### HISTORIC AND DESIGN REVIEW COMMISSION

**HDRC CASE NO: 2020-109**

**ADDRESS:** 407 KENDALL ST

APPLICANT: Lesa Rathjen /RATHJEN LESA B
OWNER: Lesa Rathjen /RATHJEN LESA B
TYPE OF WORK: Construction of an ADA ramp

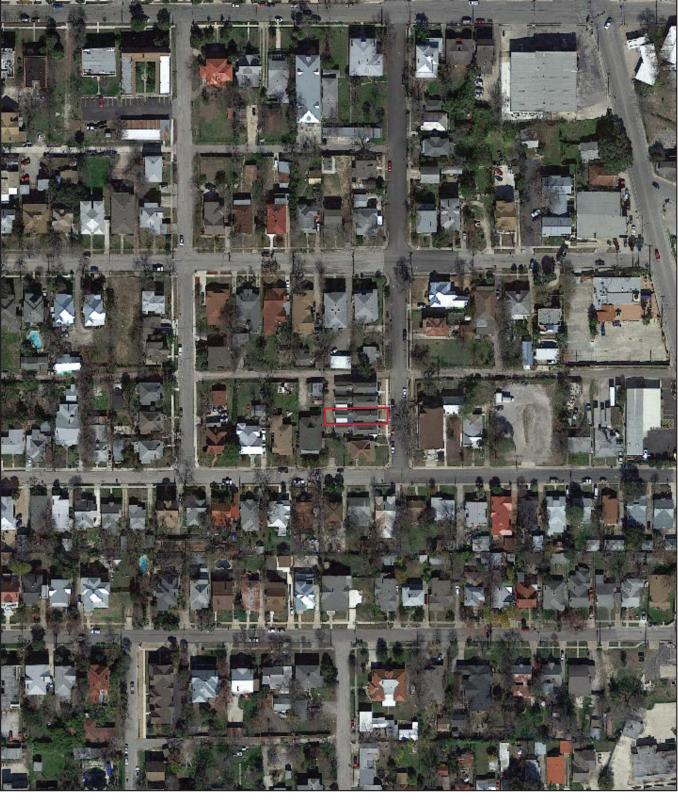
- a. The primary structure located at 407 Kendall St is a 2-story single family home constructed circa 2016. The structure is non-contributing to the Tobin Hill Historic District.
- b. RAMP The applicant has proposed to construct a permanent ADA ramp from the existing front porch. Presently, a temporary wooden ramp exists and the proposed new ramp would be installed in the same location. The ramp would extend from the front porch to the front yard and would be visible from the public right-of-way. The final materials have not been specified. Staff finds that the ramp would be minimally impactful to the structure and the public right-of-way and finds it appropriate with the stipulations listed in the recommendation.

Staff recommends approval based on findings a through b with the following stipulations:

- i. That the applicant submits a site drawing and elevation drawings of the proposed ramp with dimensions indicated for staff review and approval prior to the issuance of a Certificate of Appropriateness.
- ii. That the applicant submits final material specifications for staff review and approval prior to the issuance of a Certificate of Appropriateness.
